Title		
SolderingStation_Power.SchDoc		
Size	Number	Revision
A4		4
Date:	8-31-2021	Sheet of
File:	Z:\Documents\..\SolderingStation_Power.SchDoc	1

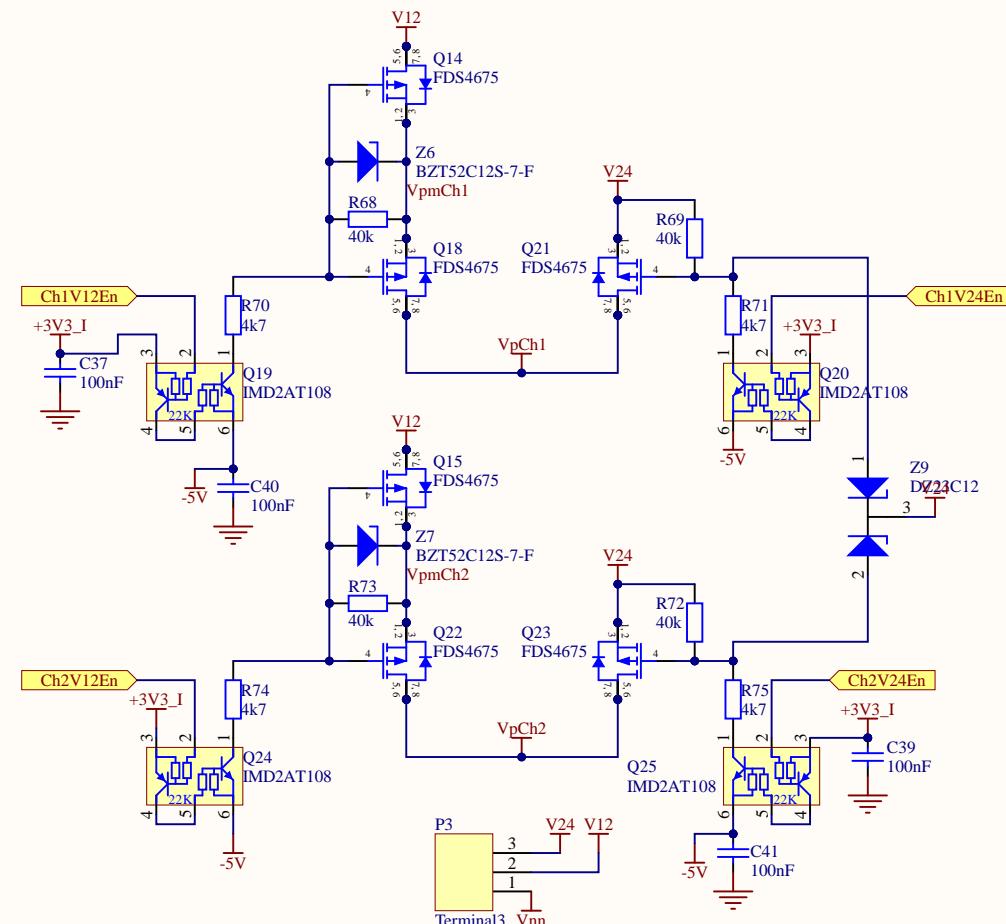
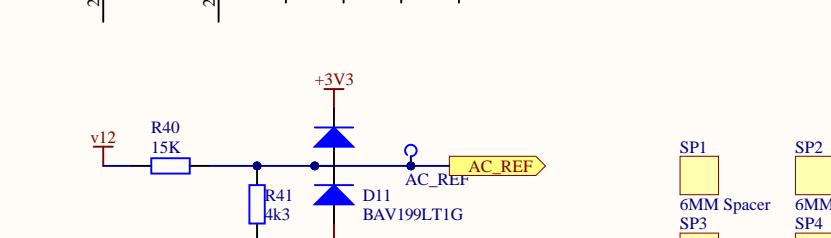
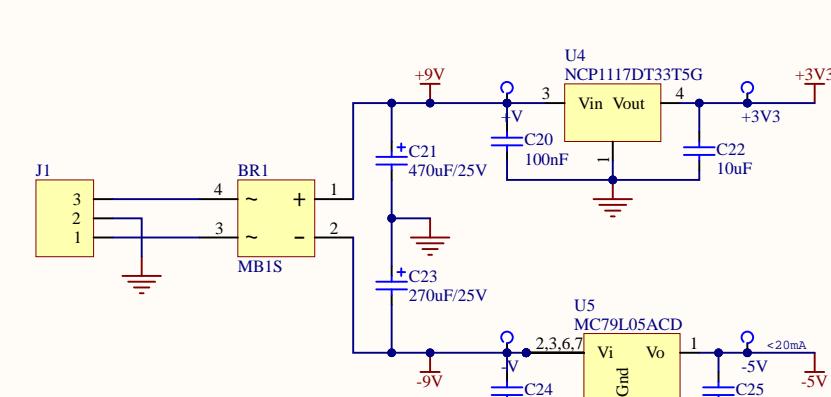
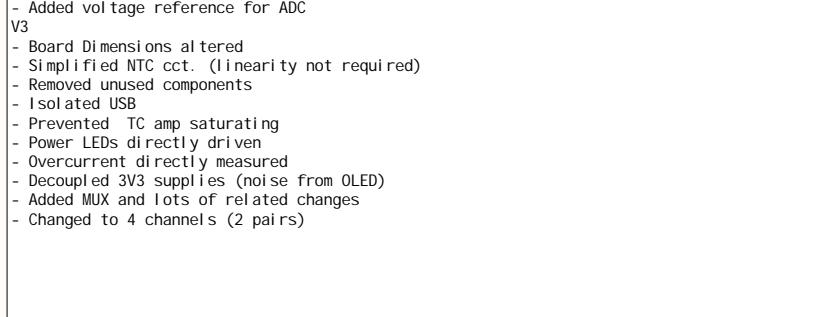
V2
- Added Setback
- Changed current source IC etc.
- Added voltage reference for ADC

V3
- Board Dimensions altered
- Simplified NTC cct. (linearity not required)
- Removed unused components
- Isolated USB
- Prevented TC amp saturating
- Power LEDs directly driven
- Overcurrent directly measured
- Decoupled 3V3 supplies (noise from OLED)
- Added MUX and lots of related changes
- Changed to 4 channels (2 pairs)
